**ON BEHALF OF CENTER FOR BIOLOGICAL DIVERSITY**  
**COMMENTS OF BILL POWERS, P.E.**  
**ON ELDORADO-IVANPAH TRANSMISSION PROJECT DRAFT EIR/EIS**

June 21, 2010

## I. Introduction

**Figure 1. IOU Substation peak loads, 30% of peak load, and 10 MW reference line**

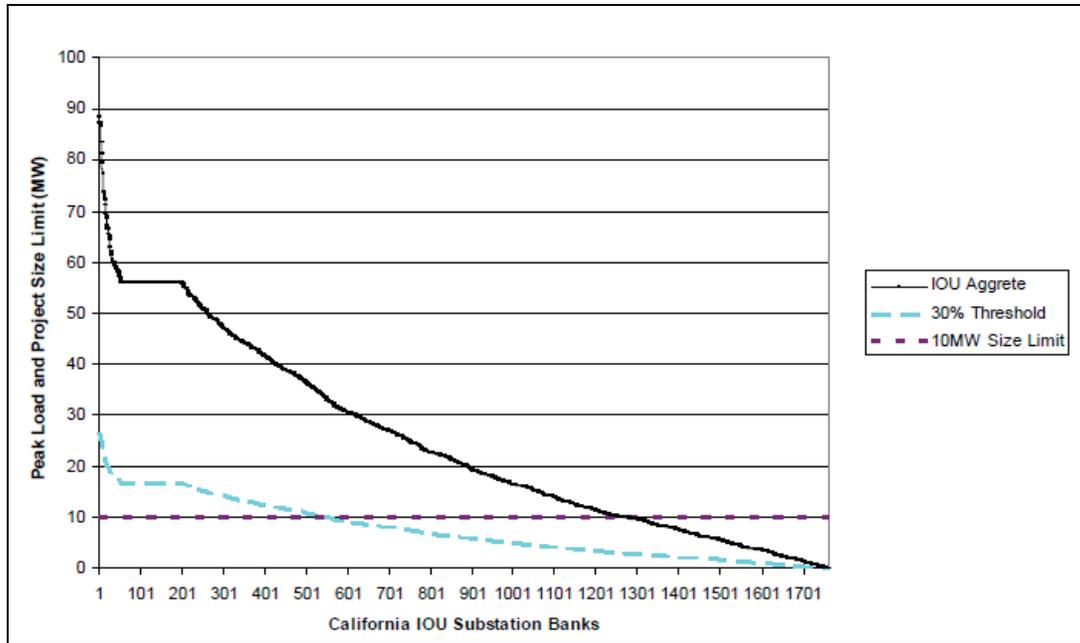
As a component of the DG FIT development process, the CPUC requested data on peak loads at all IOU substations from the IOUs and compiled that information graphically as shown in Figure 1. According to the CPUC, this data was obtained from IOU distribution engineers.<sup>19</sup> I calculate that approximately 13,300 MW of PV can be connected directly to IOU substation load banks based on the data in Figure 1. The supporting calculations for this estimate are provided in Table 1.

The IOUs provide about two-thirds of electric power supplied in California, with publicly-owned utilities like the Los Angeles Department of Water & Power and the Sacramento Municipal Utility District and others providing the rest.<sup>20</sup> Assuming the substation capacity pattern in Figure 1 is also representative of the non-IOU substations, the total California-wide PV that could be interconnected at substation low-side load banks with no substantive substation upgrades would be  $[13,300/(2/3)] = 19,950 \text{ MW}$ .

**Figure 3. Cost of commercial rooftop PV identified by DOE**

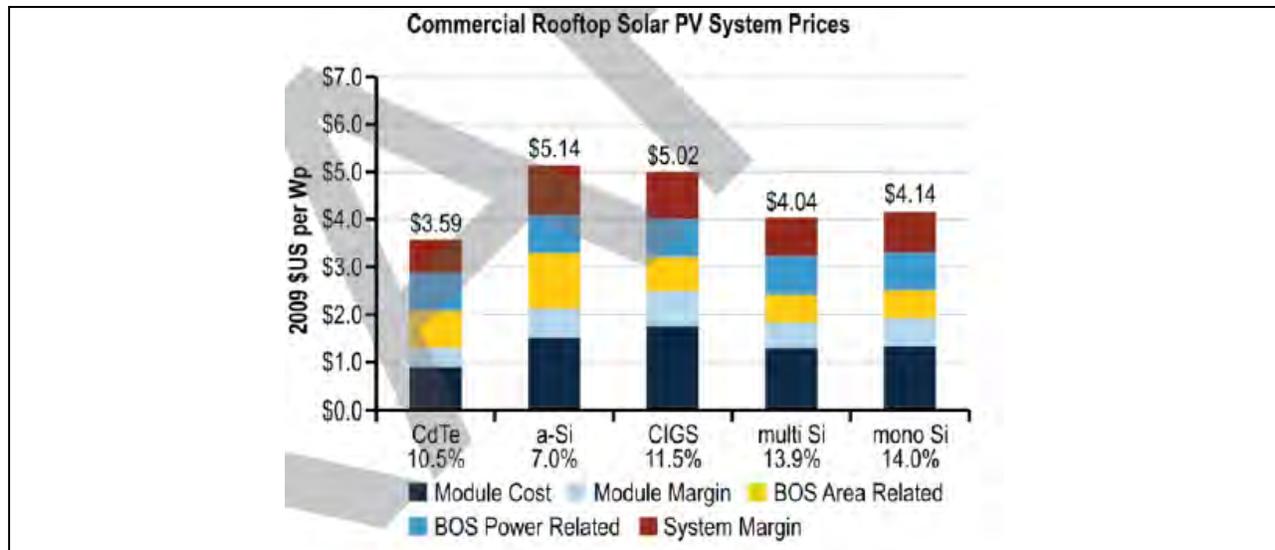
The May 2010 DOE Solar Vision Study (draft) projection of current commercial rooftop PV capital cost is provided in Figure 3.<sup>43</sup> These capital cost values are provided in Wdc. As shown in Figure 2, the current capital cost of commercial rooftop polysilicon PV (multi Si and mono Si) is approximately \$4/Wdc. RETI identifies the range of dc-to-ac conversion factors of 0.77 to 0.85.<sup>44</sup> Using an average dc-to-ac conversion factor of 0.80, the capital cost of commercial rooftop polysilicon PV is approximately  $\$4/\text{Wdc} \div 0.80 = \$5/\text{Wac}$ . This is incrementally less than the \$5.35 to \$5.55/Wac capital cost of dry-cooled solar thermal, and the commercial rooftop PV array could be as little as 1/1,000<sup>th</sup> the size of the solar thermal plant. The most common form of thin-film PV, CdTe (cadmium-telluride), is lower in cost than polysilicon PV at approximately \$3.60/Wdc. This converts to  $\$3.60/\text{Wdc} \div 0.80 = \$4.50/\text{Wac}$ .

**Figure 4. Location of Westlands Water District and Path 15<sup>74,75</sup>**

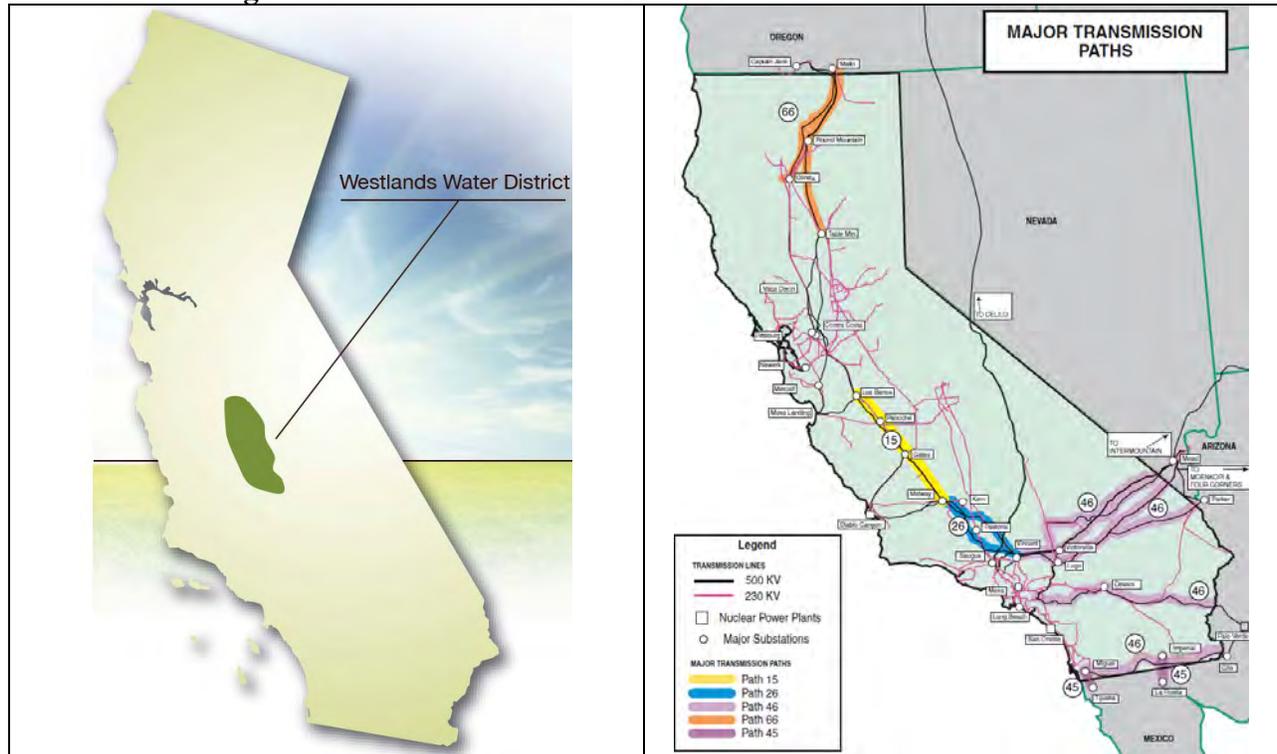
Transmission Pathway 15 passes through Westlands. Path 15 can transmit 5,400 MW from south-to-north.<sup>73</sup> The transmission capacity from north-to-south is 3,400 MW. The location of Westlands relative to Path 15 is shown in Figure 4.

5,000 MW of solar power can be developed in Westlands with potentially no expansion of the existing Path 15 high voltage transmission capacity that serves Westlands now.
